LatticeMico32 Migration Concerns Post ispLEVER 8.1 and Diamond 1.0

November 2010 Technical Note TN1221

Figure 3. ispLEVER 8.1 SP1/Diamond 1.1 and Later

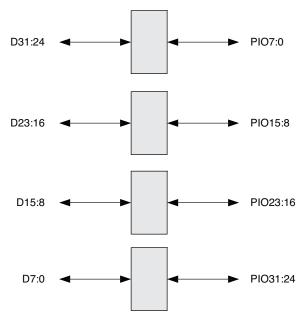
The GPIO component has had a few minor modifications made to it. The original GPIO component only responded to 32-bit memory transfers. If the SEL lines coming from the LatticeMico32 were not all active then the transaction to the GPIO registers were ignored. The new GPIO component enables access to each individual byte in the 32-bit register using 8-bit memory accesses.

Another change that has been made is to explicitly describe which port I/O pin is controlled by each byte within the register. The new definition provides an addressing order that is friendly to an 8-bit Wishbone master. This has a side effect for the LatticeMico32. The side effect is to swap the port I/O bytes relative to the LatticeMico32's preferred big endian format. This is illustrated in Figures 2 and 3.

There are a couple of options open to system designers to handle the change in the GPIO's new behavior.

- The LatticeMico32 platform developer can place a top-level HDL wrapper around the Verilog code generated by LatticeMico32 System Builder.
- The C/C++ firmware developer can update the code that accesses the GPIO registers.

Figure 7. Example reset_i Controller

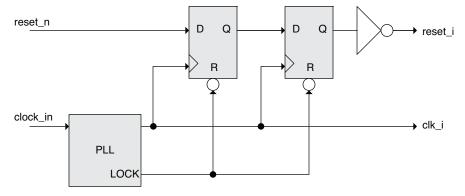
After restoring the PLL in the wrapper it is recommended that a circuit to manage *reset_n* be implemented. LatticeMico32 platforms clocked by a PLL operate best when *reset_n* is released after the PLL reports that it has locked to the input frequency. One possible solution is shown in Figure 7.
